RE: Blaisdell Industrial Sand Terminal Project  
6350 67<sup>th</sup> Ave NW  
Blaisdell, ND 58718

Temporary Variance Permit  
Case No. WM-13-56

SUBJECT: PARTIAL PLAN OF COMPLIANCE

6 **WM-13-56** Filed: 4/17/2013 Pages: 10  
**Partial plan of compliance**

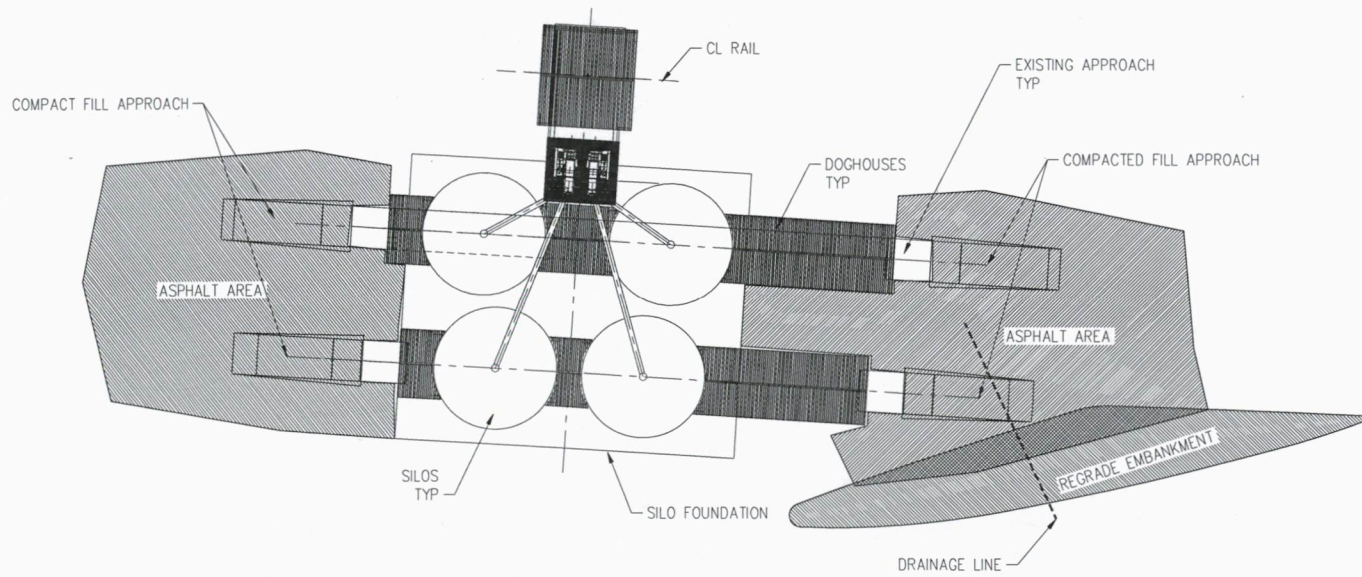
1. 12 feet of level concrete is required for the portion of the approach adjacent to the scale. The approaches in place have 10 feet of level concrete.
2. The remaining approach is sloped greater than the required 1/3 inch per foot. The approaches in place have a slope of 1.5 inch per foot.

The ND requirement states "the first twelve feet of approach from the scale must be metal or concrete", and that "slope of the approaches away from the scale deck may not exceed one-third in per foot". By the ND requirement, the slope of the approach should start at the scale deck, and the ND requirement does not call for any level approach area adjacent to the scale.

The level approach requirement shows up in NIST Handbook 44. The Handbook 44 requirement is 10 foot of level approach adjacent to the scale. Note that the scales are fully compliant with the Handbook 44 requirements, including both approach level plane and slope.

1. Regrade the existing southeast site embankment, removing approximate 30 feet of a curved 20 foot high embankment. Remove the material from the site.

2. Trim existing concrete approaches 12 feet from the inside edge, and dispose of the waste reinforced concrete material.
3. Place compacted fill subgrade in the approach area, sloped at the ND standard slope of 1/3 in per foot. The area would extend approximately 50% longer than the current approaches, and be sloped to the sides of the approach per standard fill procedures.

4. Install a subgrade drainage system to drain the areas between the approaches, as in extending the approaches, and at the overall gradation of the site, an area between the approaches.

5. Asphalt pave the approaches and the area between and around the approaches, as a gravel surface will not allow proper drainage. The asphalt area would have to continuously maintained as the available slope for drainage is less than recommended.
